10/759,025

Office Action Summary

DETAILED ACTION

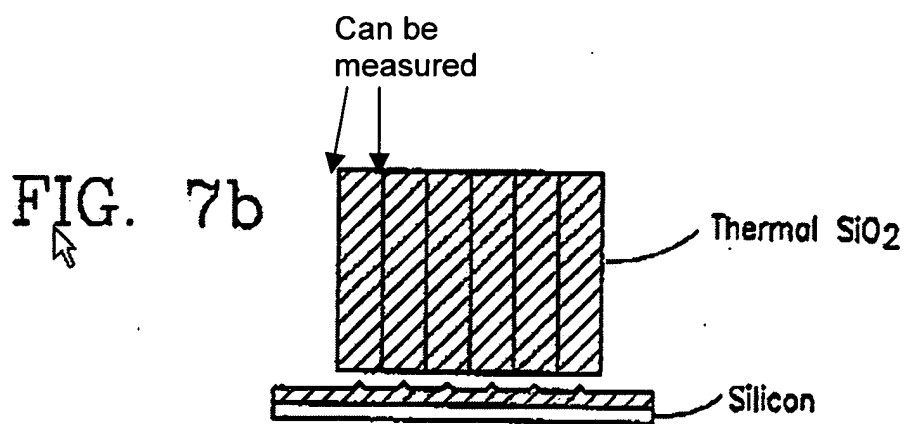
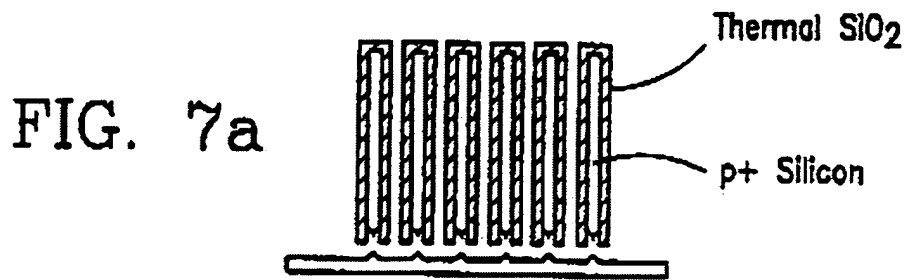
With respect to claim 20, MacDonald et al. discloses, "A method for manufacturing an optical device, comprising the steps of:

etching a semiconductor substrate with a predetermined mask (14) so that a plurality of semiconductor wall is formed between the trenches (see Figure 7a); and thermally oxidizing the substrate so that the semiconductor wall is transformed into a semiconductor oxide wall (thermal SiO₂; Oxidation discussed also in Figure 5b; Col. 7: lines 35-42; Col. 5: lines 52-58) and the trench is filled with semiconductor oxide (see Figure 7b),

wherein the semiconductor oxide wall and the semiconductor oxide in the trench provide an optical part (light waveguide 168 in Figure 6), and

wherein the optical part is integrally formed with the substrate (10), and passes light therethrough.

wherein the semiconductor oxide wall (thermal SiO₂ in figure 7a) and the semiconductor oxide in the trench are adhered together in the step of thermally oxidizing the substrate (see Figure 7b: Col. 7: lines 59-61)."

wherein the widths of both of the trench of the semiconductor wall are determined (can be measured) in such a manner that the trench is filled with the semiconductor oxide and at the same time the semiconductor wall is transformed into the semiconductor wall in the step of thermally oxidizing the substrate (see figure 7a and 7b below)."
